**From:** [Gregory Henrich](#)  
**To:** [MRC - jpa Permits; Johnson, Mike \(MRC\)](#)  
**Subject:** VMRC #24-2233 JPA JAMES AND MELISSA WADE 8334 Chestnut Point Ln, Hayes, VA 23072  
**Date:** Tuesday, October 29, 2024 2:10:53 PM  
**Attachments:** [Outlook-utx1nafv.png](#)  
[JIMMY WADE 8334 Chestnut Point Ln, Hayes, VA 23072 BULKHEAD REPLACEMENT REV 1.pdf](#)  
[JPA JAMES AND MELISSA WADE 8334 Chestnut Point Ln, Hayes, VA 23072.pdf](#)

Please upload this permit. We have moved from a revetment to a bulkhead replacement.

**From:** [Johnson, Mike \(MRC\)](#)  
**To:** [MRC - Ipa Permits](#)  
**Subject:** FW: MRC#24-2233 Wade Pier application  
**Date:** Tuesday, November 12, 2024 11:12:49 AM  
**Attachments:** [Outlook-2ub0fecf.png](#)  
[Pages from JIMMY WADE 8334 Chestnut Point Ln, Hayes, VA 23072 Floating dock REV 1.pdf](#)

FLOATING PIER CUTSHEET

REVISIONS		Permit Division LLC WADE 8334 CHESTNUT POINT LN	PLANVIEW OF PIER AND BOAT HOUSE
1	MM/DD/YY		
2			
3			
4			
5		A 04

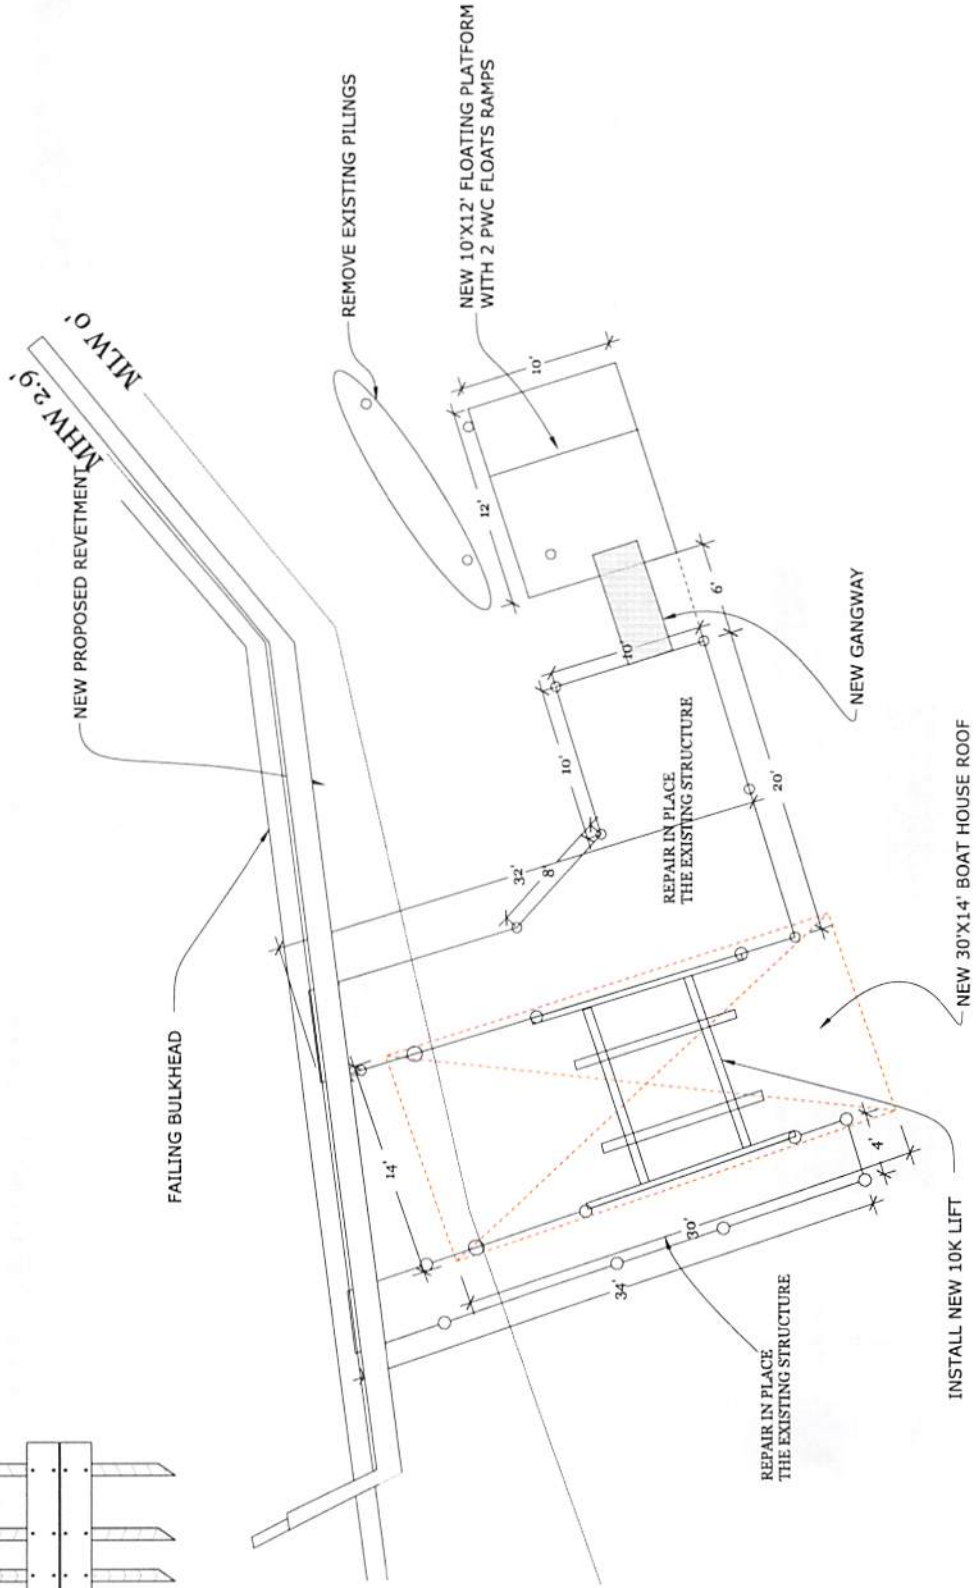
Mr. O'Connell,  
Please give me a call to discuss your navigation concerns for Mr. Wade's additions to

the pier. I want to get your input on where the deeper water in this creek/canal is located.

Mike,  
Please give me depth measurements across the waterway in relation to the new floating dock.

After talking with the Homeowner, we will make sure it does not go out any further than the existing pier.
